# CITY OF ALBUQUERQUE

**Re: McDonald's**  
**5001 Gibson Blvd SE**  
**30-Day Temporary Certificate of Occupancy-Transportation Development**  
**Transportation Development Final Inspection**  
Engineer's/Architect's Stamp dated 01-09-18 (L18D053)  
Certification dated 07-31-18

TRAFFIC  
CIRCULATION  
PLAN

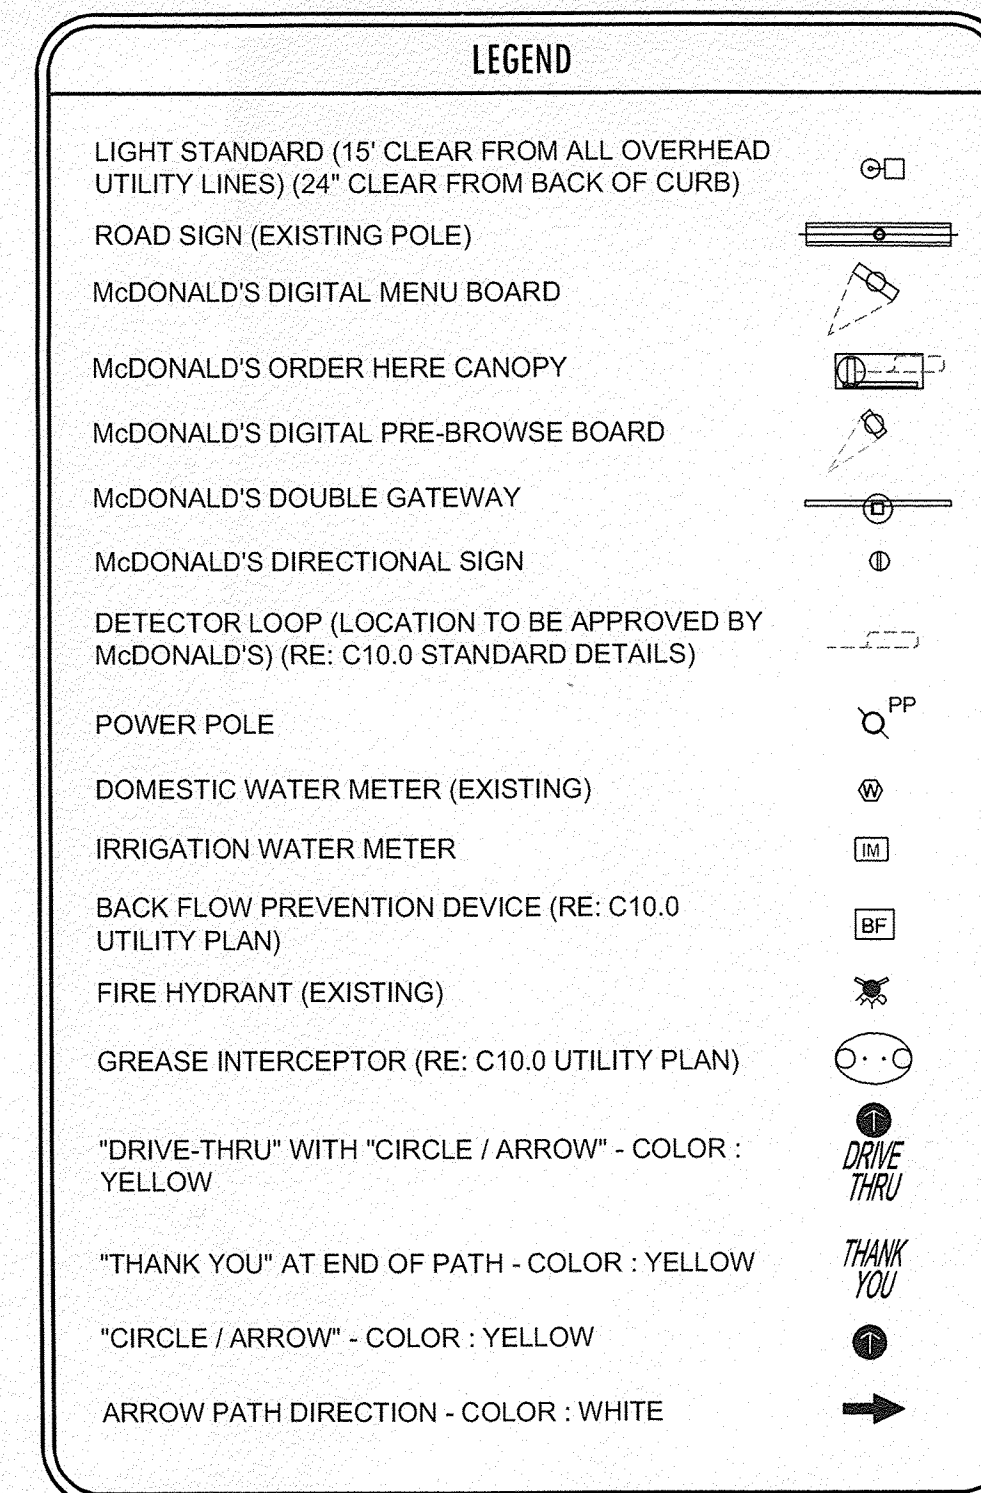
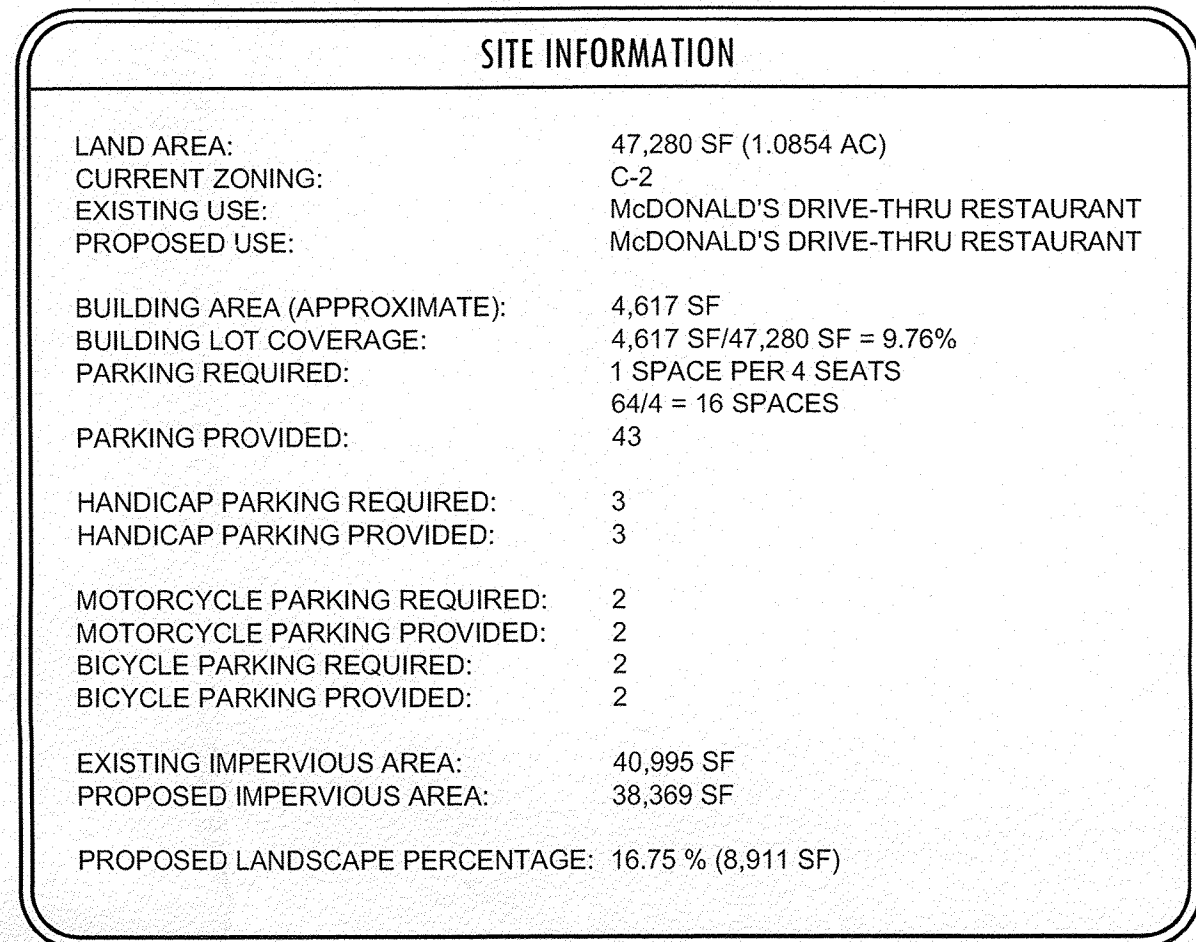
1. Please add Motorcycle parking signs & McDonalds OOSP Sign.
2. Please add NO Parking in the ADA access aisle.
